Access Compliance Report

Public Rights-of-Way

(Curb Ramps)

| Intersection ID: 53374 | Main Street: PPC_DR | Cross Street: CRAVEN_THOMAS_RD | Location: NE |

| ADA ID: 53B7A736F7D2 | Ramp Type: Perp | Initial Pass/Fail: Fail | Overall Compliance: No |

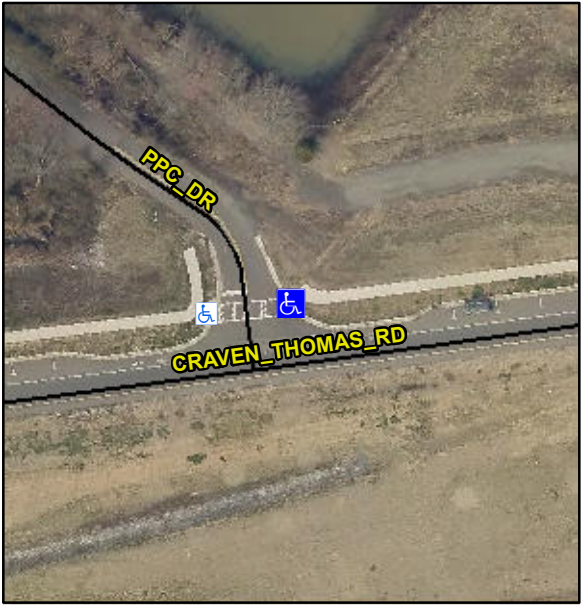
| Codes/Mitigation Info/Possible Solution | | | Field Measurements/Component Compliance | | | |
|--|--|--|---|-----------------------------|-------------|-------------------|
| | Remove & Replace Entire Ramp. | | No | Ramp Length (in) | 71.0 | No |
| | | | Yes | Ramp Width (in) | 48.0 | No |
| <p>Surveyor Notes:</p> <p>N/A</p> <p>PROW/ADA:</p> <p>R304.2.2, R304.5.3</p> | | | N/A | Flare Type RT | N/A | N/A |

| Codes/Mitigation Info/Possible Solution | | | Field Measurements/Component Compliance | | | |
|--|--|--|---|-----------------------------|-------------|-------------------|
|  | Possible Solutions: | | Compliance | Description | Data | Compliance |
